VALIDATION OF THE REVISED MONITORING PLAN

Gimcheon PV Power Plant Site 1 CDM Project

UNFCCC Ref. No. 2683

REPORT No. 2011-04

3.4 The revision of Monitoring Plan

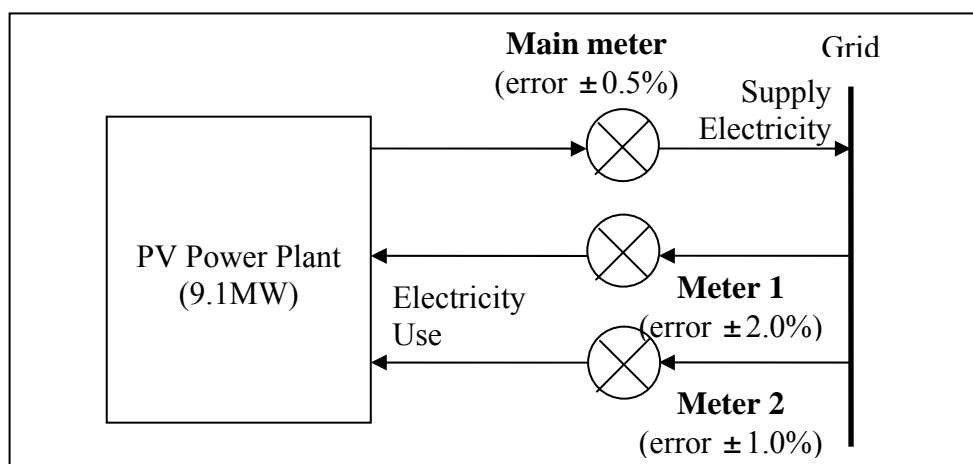
Meter to measure electricity from the Grid is added as requested by Korea Electric Power Corporation (KEPCO)

EGy, net electricity generation by the project activity is only parameter to be monitored to calculate emission reduction by this project activity during the crediting period. To monitor EGy, measurement of electricity supplied to the Grid and electricity supplied from the Grid need to monitor. According to the registered PDD Version 5, there are total 2 meters: 1 meter to measure electricity supplied to the Grid and 1 meter to measure electricity from the Grid respectively. However, as per 'Electricity Enterprises Act', additional meter to measure electricity from the Grid is required to be installed and it measures general electricity consumption for street lights, security system within the project boundary which is not directly related to power generation by this project activity. In conclusion, there are total 3 meters to monitor EGy: 1 meter to measure

electricity supplied to the Grid (main meter) and 2 meters to measure electricity delivered from the Grid to the Project (One for the industrial electricity use and other one is to measure general electricity use).

The validation team checked notice issued by KEPCO to trail changes in number of meters at the project site. The registrar of newly added meter is also checked to confirm accuracy level of meter ($\pm 1.0\%$), serial number and date of installation of the meter (6 April 2011) as well as physical site visit.

And it is also confirmed that PP have well described monitoring plan for the meter added including calibration frequency in the revised monitoring plan and the revised monitoring plan have implemented properly.
